## BOROUGH OF AMBLER COMMITTEE MEETING

3. **AMBLER LAKEVIEW REVIEW**  
Review the 9 N. Maple Street Sketch Plan proposing a 92 residential unit five story building with associated parking – Ambler Lakeview Development LP. The applicant will provide a brief presentation at the September 8<sup>th</sup> Committee meeting. (Montgomery County Planning Commission review and Borough Engineer review **attached**)

Reference: Sketch Plan Review  
Ambler Lakeview Development, L.P.  
9 N. Maple Avenue, Ambler Borough and 5 N. Maple, Upper Dublin Township  
Tax Parcel #01-00-02938-40-9; Block 01047, Unit 008  
Tax Parcel #54-00-11581-50-6; Block 54035, Unit 014

Re: MCPC #21-0200-001  
Plan Name: The Ambler  
(3 lots comprising 2.669 acres)  
Situate: 9 North Maple Street  
Ambler Borough

SHEET TITLE: **CONCEPT PLAN 'D'**

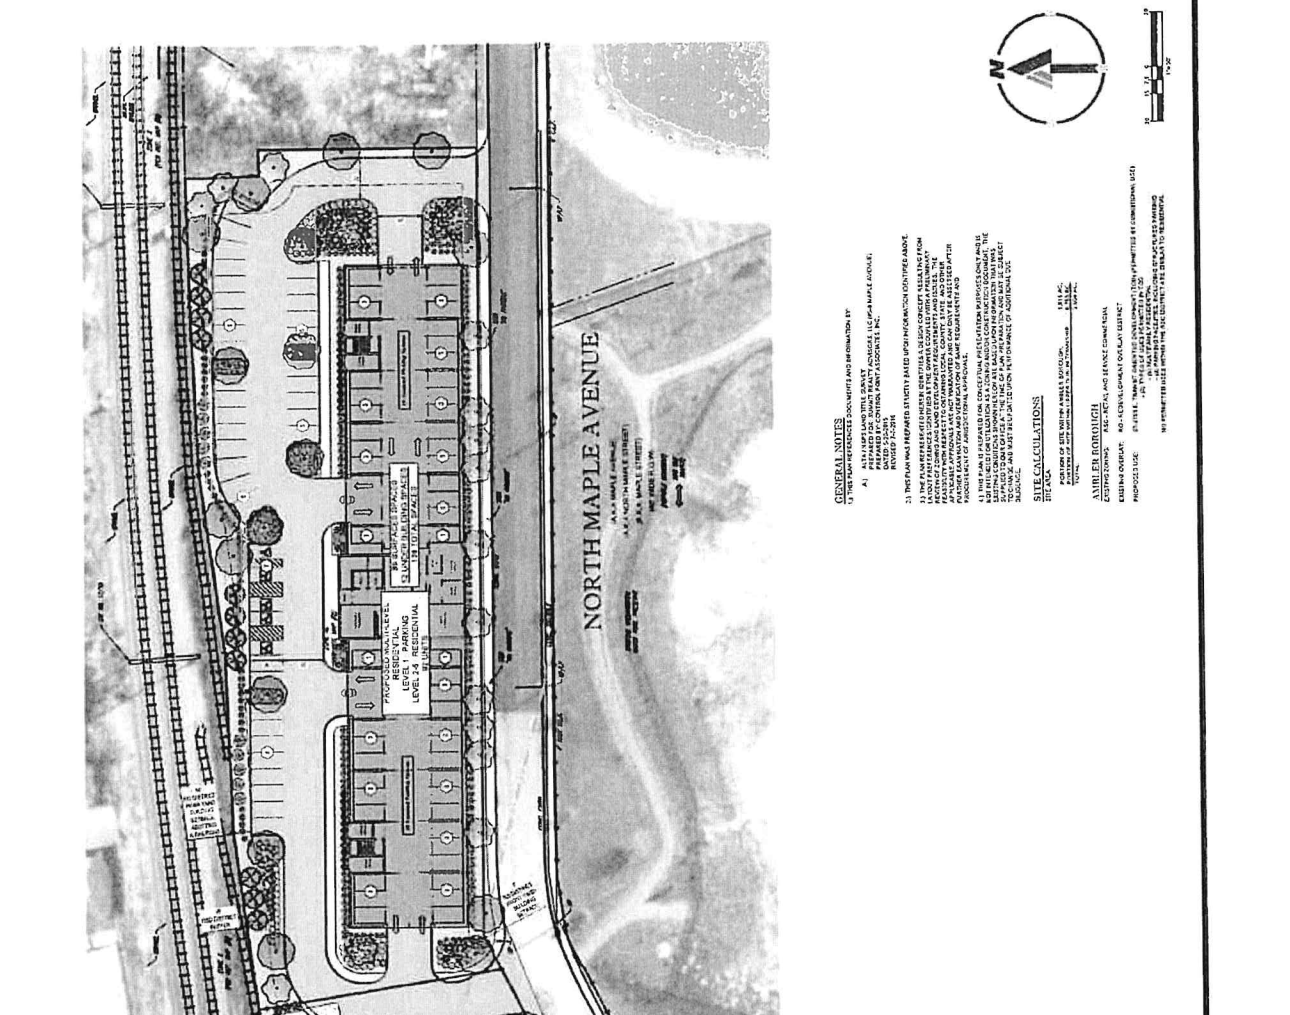
1. §27-412 & §27-2703.E(4)(i) & §27-2705.J – The sketch plan does not include site lighting. The applicant should provide a lighting plan that complies with the Borough lighting criteria.
2. §27-413 & §27-2703.E(3) & (4) – Assuming the Borough determines that the proposed use is considered a TOD Transit-Oriented Development use and based upon the current Zoning Ordinance, the proposed use will need conditional use approval.
3. §27-1907 & 1910.G – The proposed development is directly adjacent to the floodplain (Zone AE). Proposed grading at the site could affect the floodplain. There is the potential that a special exception would be needed. This will need to be evaluated upon submission of more detailed grading plans.

5. §27-2703.A(1)(b) – The parking spaces within the garage appear to be 9 feet by 18 feet. The dimensions shall be included on future plan submissions.

6. §27-2703.A(1)(d)1 – The parking garage setback is 10 feet when in joint use with another permitted use. The plan shows the building setback at 8 feet. We defer to the Borough Code Officer to determine if this is applicable to this proposed development.

15. §27-2703.E(4)(e) – It appears that the number of parking spaces proposed (138) is compliant with the requirement (1.5 space per DU). The Applicant shall provide parking calculations to demonstrate compliance with this section.

16. §27-2703.E(4)(h) & §27-402 – Green Space. The Applicant shall provide site calculations to demonstrate compliance with these sections. 20% of the gross tract area shall be set aside for open space and recreational activities.

24. §27-2705.N(1)(d) – The Applicant shall show the schematic layout of utilities and stormwater facilities on any sketch plan submission. Based on the existing impervious coverage the site may be an overall reduction in impervious.
25. §27-2705.N(2)(b) – The sketch plan should be reviewed by the Redevelopment Review Board.
26. §27-2705.N(3)(a) – The Applicant shall show an integrated and coordinated pedestrian circulation system linking the site with nearby uses and buildings, parks, transit facilities, etc.

27. §22-303.B.(5) – A sketch plan shall show significant topographical and physical features, such as floodplains, wetlands, steep slopes, woodlands and existing features. There are no existing features shown on the subject parcel.
28. §22-303.B.(6) – Proposals for control of drainage runoff shall be shown on the plan.
29. §22-310.3.A – A traffic impact study is required for this project.

**LANDSCAPE PLAN**

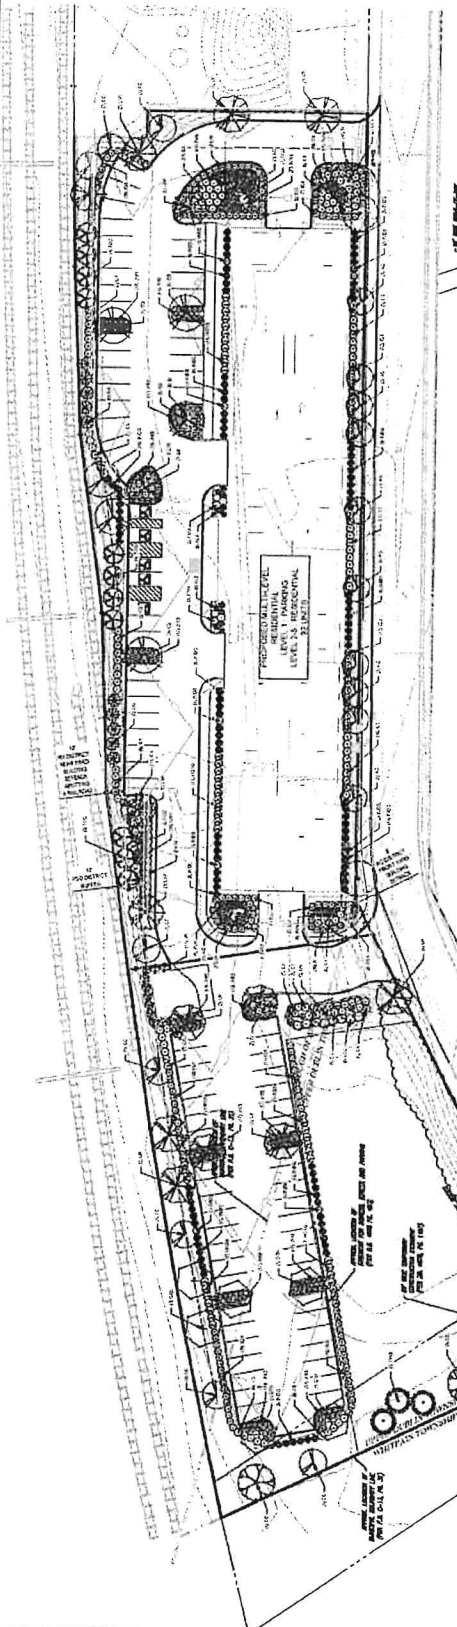
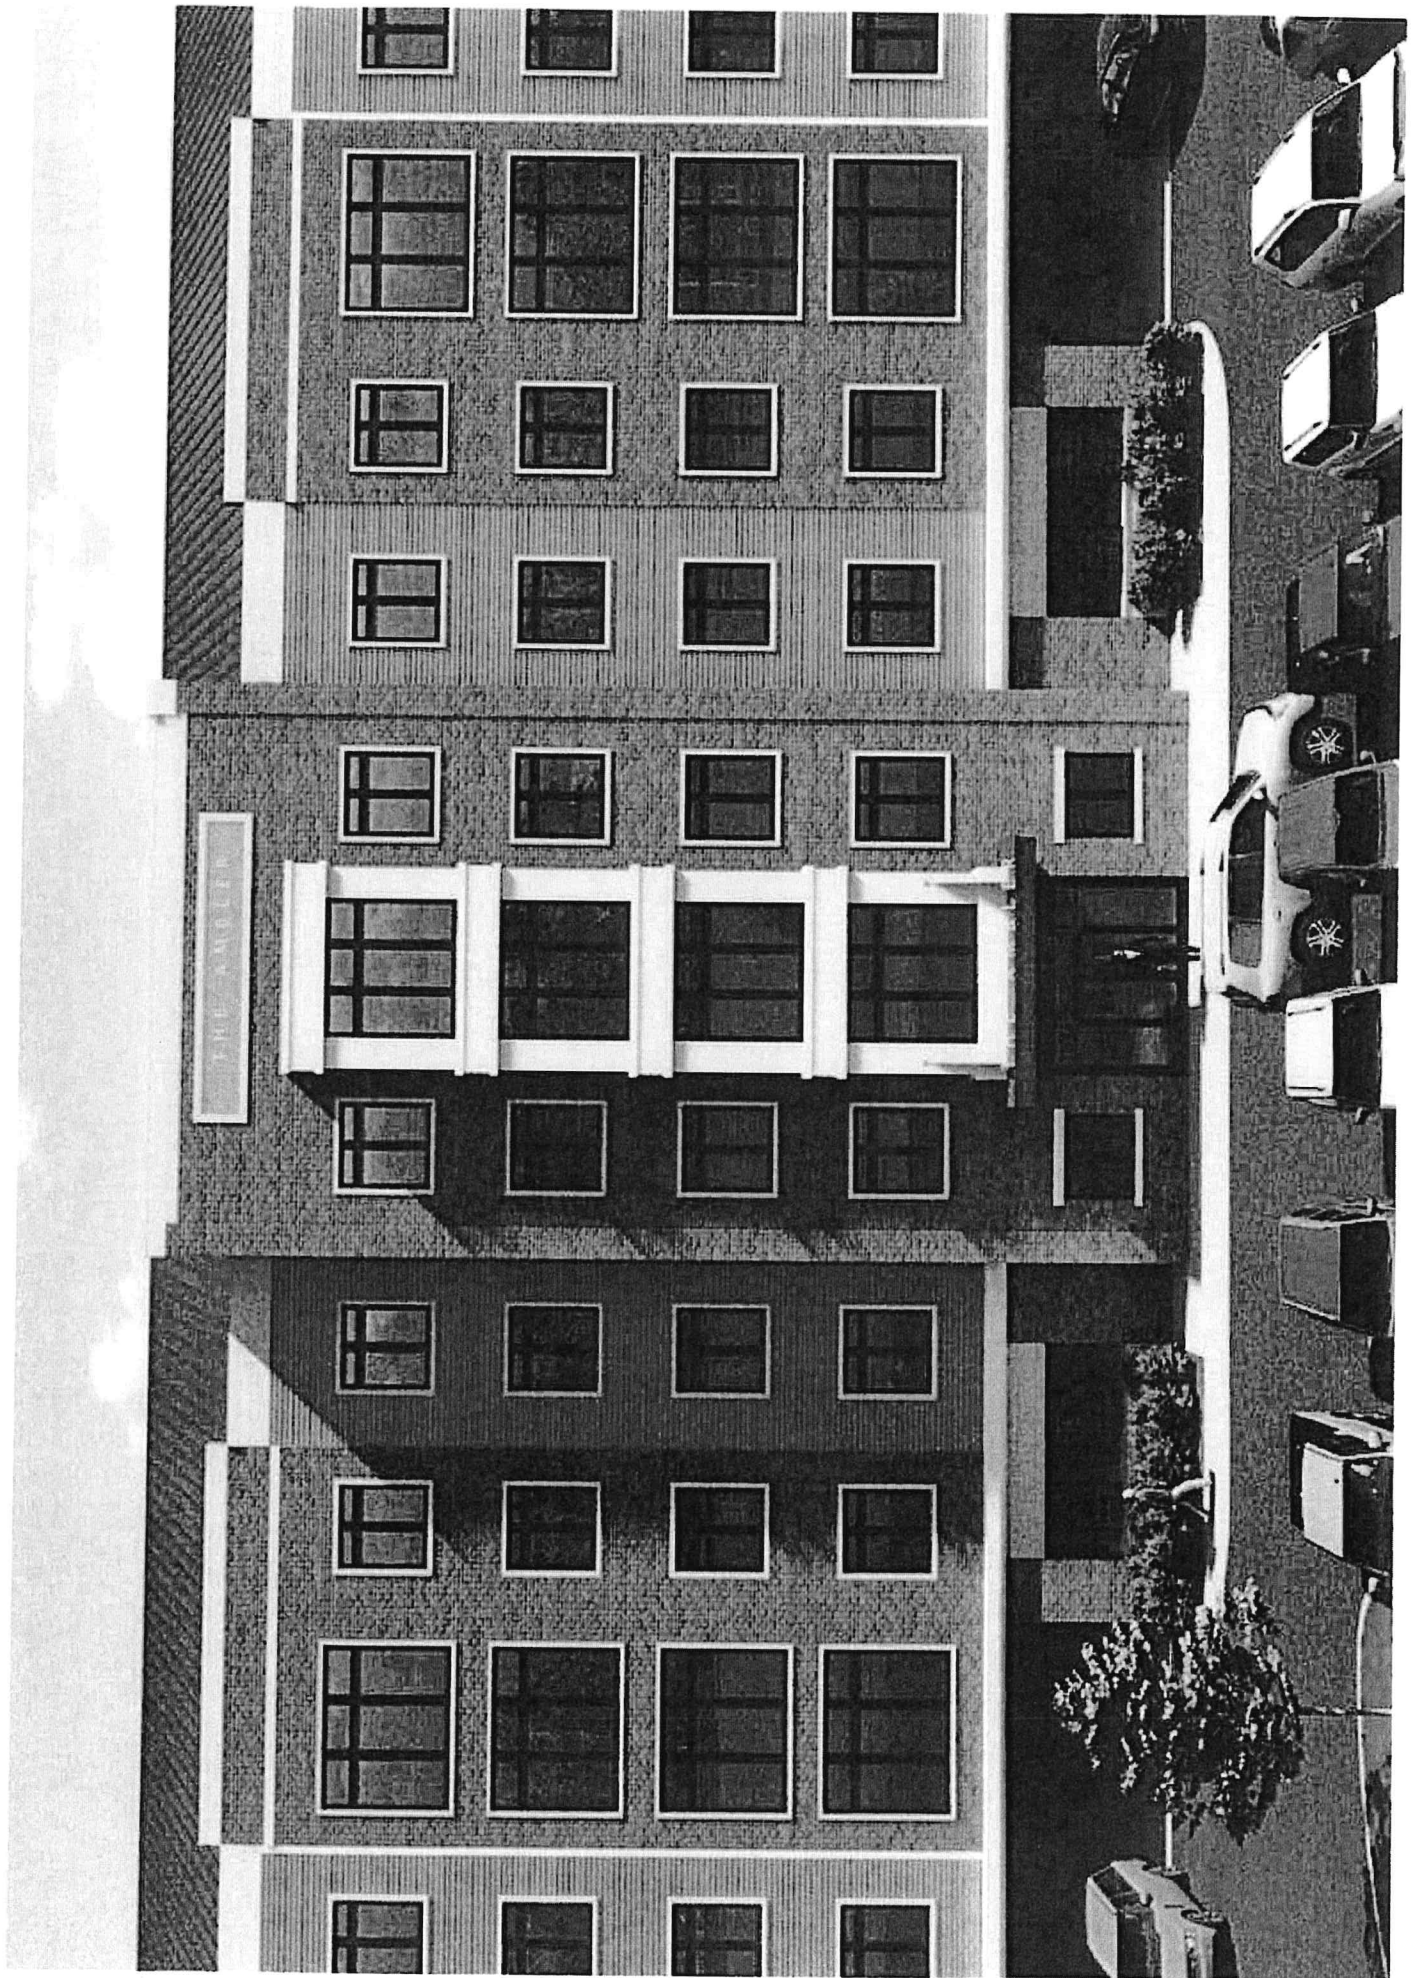
35. The sketch plan application included a conceptual landscape plan. The plan generally indicates that the applicant will be able to comply with the various landscape requirements of the Borough. Upon submission of detailed development plans, the landscape plan will be reviewed in more detail. The applicant should be aware that revisions may be required.
